Work Order ID 73642

Item Name: Crosstube Turning Detail

DART AEROSPACE LTD	Work Order: 73642
Description: Crosstube Assembly (205/212 High Aft)	Part Number: D212-664-241
Inspection Dwg: D212-664-241 Rev: D	Page 1 of 1

DRAWING NO. D212-664-241	TITLE CROSSTUBE ASSY (205/212 HI AFT)	REV. D	DART AEROSPACE LTD. ENGINEERING ORDER		D.E.O. NO. D212-664-241-D-1	SHEET NO. SHEET 1 OF 2	SCALE NTS
DRAWN	CHECKED	MFG. APPR.	APPROVED	DE APPR.			
DATE 11.04.07	DATE 11.04.11	DATE 11.04.12	DATE 11/04/12	DATE 11.04.12

**D212-664-241/-241B
ASSEMBLY DETAIL**

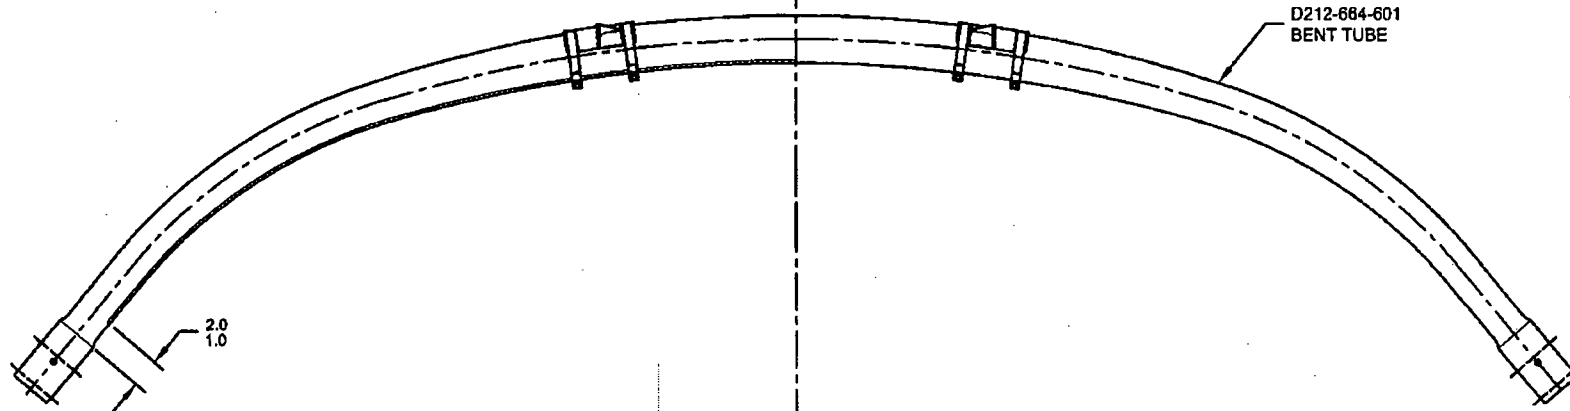
PURPOSE:

ADD AN INSPECTION WINDOW TO UNDERSIDE OF CROSSTUBE.

NOTES 2 OF SHEET 1 IS AMENDED AS FOLLOWS:

- 2) FINISH: CHEMICAL CONVERSION COAT PER DART QSI 005 4.1
PRIME INSIDE AND OUTSIDE PER DART QSI 005 4.2
MASK UNDERSIDE OF CROSSTUBE AS SHOWN (HATCHED AREA) AND
PAINT OUTSIDE PER DART QSI 005 4.2
REMOVE MASKING AND APPLY CLEAR COAT

MASK AREA PRIOR TO PAINTING,
REMOVE MASKING AFTER PAINT
AND APPLY CLEAR COAT
